SERVICE INFORMATION LETTER SZ47-003B

TO: ALL TWIN OTTER OPERATORS WITH ZEE SYSTEMS AIR CONDITIONING.

REF: SZ47-003-1A/-2A BLOWER ASSEMBLIES.

SZ54-002 EVAP ASSY

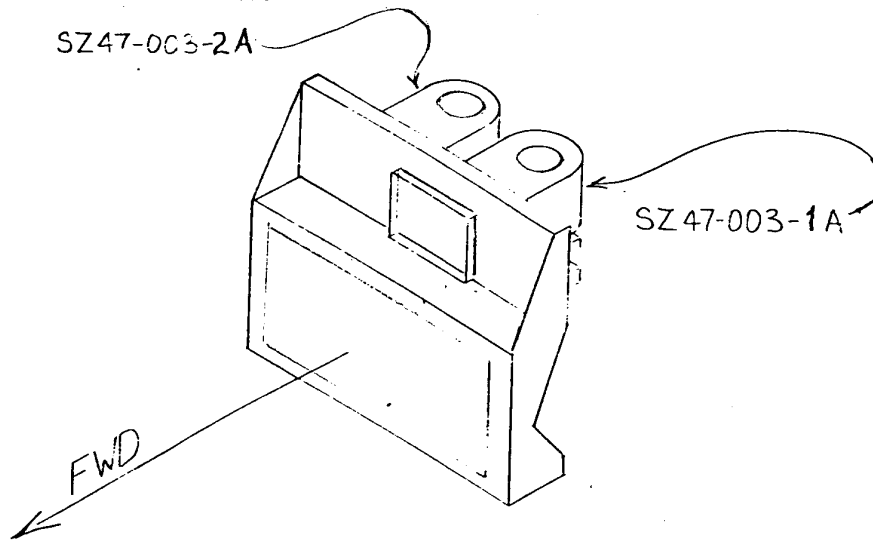
IT HAS BEEN BROUGHT TO OUR ATTENTION THAT SOME OF THE ENDING DASH NUMBERS OF THE BLOWER ASSEMBLIES ON THE EVAPORATOR HAVE BEEN INCORRECTLY IDENTIFIED. IN RESEARCHING THIS PROBLEM WE HAVE DISCOVERED THAT THE BLOWER DRAWING AND THE EVAPORATOR ASSEMBLY DRAWING SHOW CONFLICTING PART NUMBERS. THE BLOWER ON THE PILOT (LEFT) SIDE OF THE AIRCRAFT SHOULD BE IDENTIFIED AS -1A, THE BLOWER ON THE CO-PILOT (RIGHT) SIDE OF THE AIRCRAFT SHOULD BE IDENTIFIED AS THE -2A. THEY MAY BE IDENTIFIED INCORRECTLY (A -1A IDENTIFIED IN THE PLACE OF A -2A ETC.). INCORRECTLY IDENTIFIED BLOWERS IN NO WAY POSE ANY DANGER TO THE SAFE OPERATION OF THE UNIT BECAUSE THE BLOWERS CAN ONLY FIT ONTO THE EVAPORATOR ASSEMBLY ONE WAY REGARDLESS OF THEIR IDENTIFICATION. THE CONFUSION COMES WHEN ORDERING A REPLACEMENT BLOWER. WHEN ORDERING REPLACEMENT BLOWERS DO NOT ORDER BY THE PART NUMBER OF THE UNIT REMOVED FROM THE AIRCRAFT, AS IT MAY BE INCORRECTLY IDENTIFIED, PLEASE SPECIFY THE BLOWER ON THE PILOT OR CO-PILOT SIDE OF THE AIRCRAFT. PLEASE REVIEW THE DRAWING BELOW FOR FURTHER CLARIFICATION.
